**RE: Forest Lakes Phase II Water Tank, EA-17-109
Site Development Plan - Letter of Intent**

LOI V_1 redlines.pdf Markup Summary

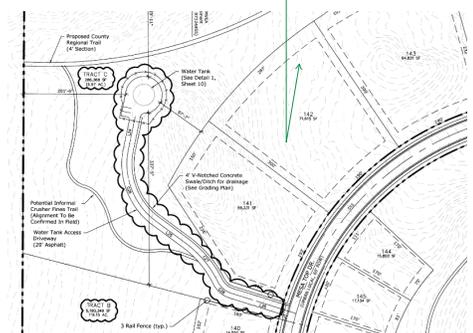
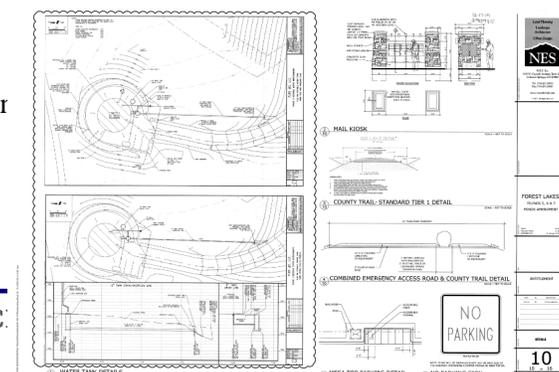
sheet 5 and 10 of recorded PUD- The site dev plan must meet these minimum standrds

sheet 5 and 10 of recorded PUD- The site dev plan must meet these minimum standrds

sheet 5 and 10 of recorded PUD- The site dev plan must meet these minimum standrds

sheet 5 and 10 of recorded PUD- The site dev plan must meet these minimum standrds
